Addendum #1

REQUEST FOR PROPOSALS

RFP-09-21 Rod Brind 'Amour Arena Mechanical Upgrades Strathcona Gardens

Issued October 7, 2021

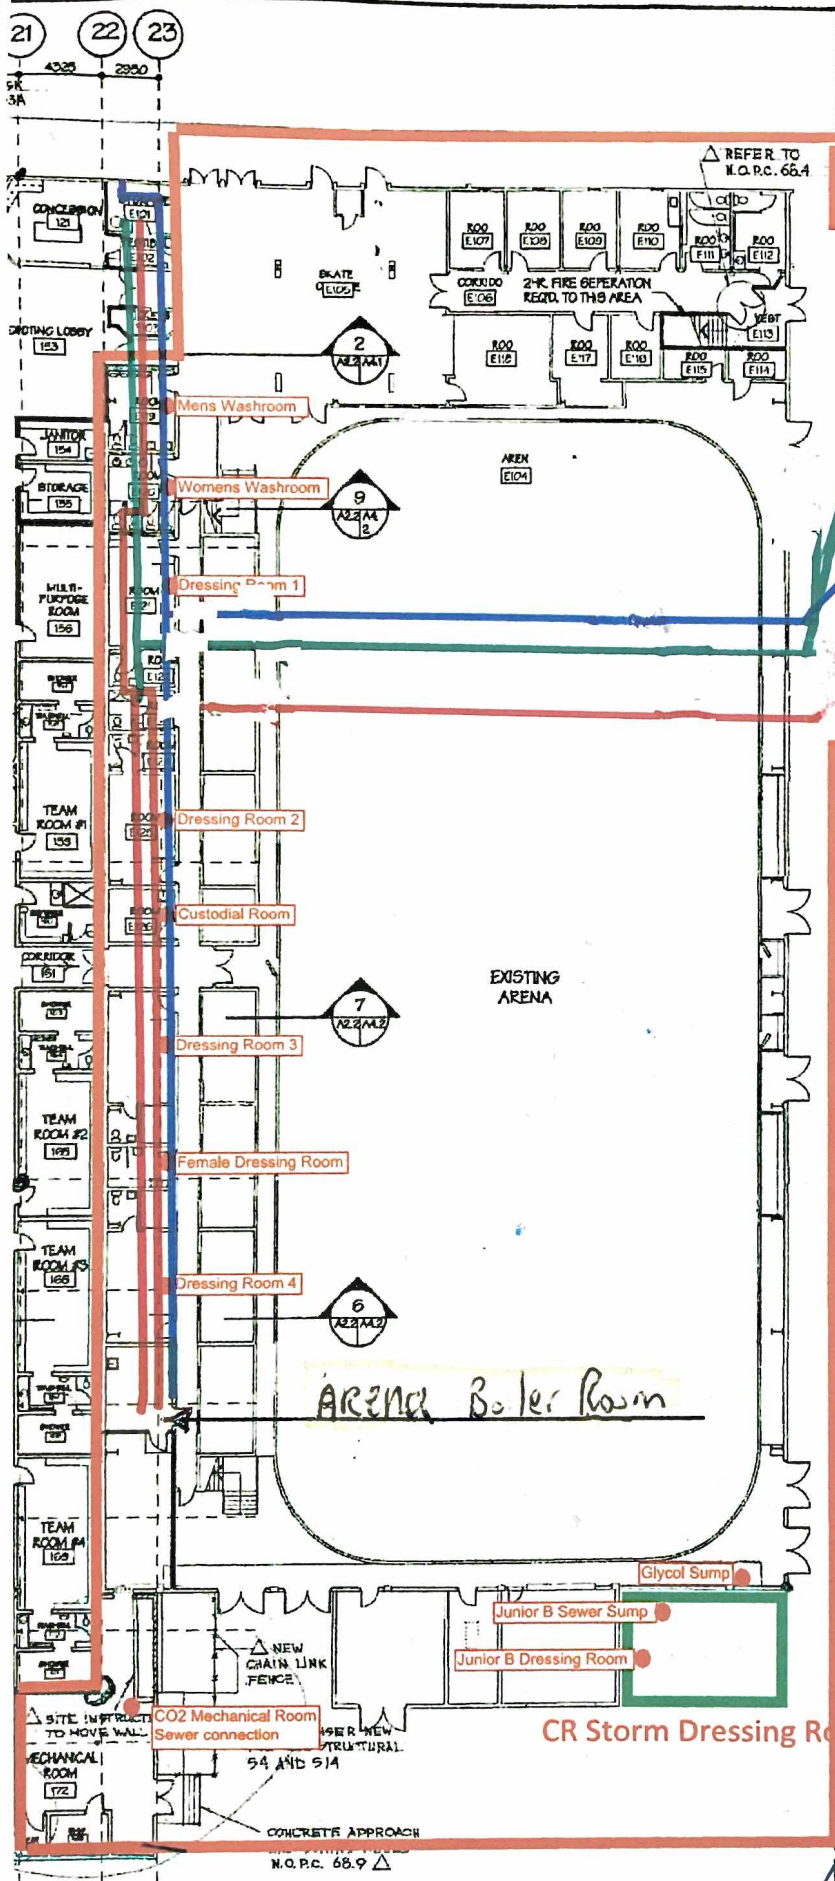
Provide direction on pipe sizing

1 inch pex extends the hot water loop to the concession storage room, please replace the whole loop in copper.pex green

- 1. Please see attached PDF for current mainline configuration.*
- 2. Current sizing does meet the requirements outlined in available pipe sizing charts and there have not been any patron complaints about water pressures or temperatures.*
- 3. Any changes required to meet code sizing requirements discovered during the course of construction can be considered a change and out of scope rates will apply.*
- 4. Replace temporary pex line from the Referee room to the concession in copper.*

Blue / cold - 2 1/8 OD

Red / hot / supply 1 1/8

Return / 7/8
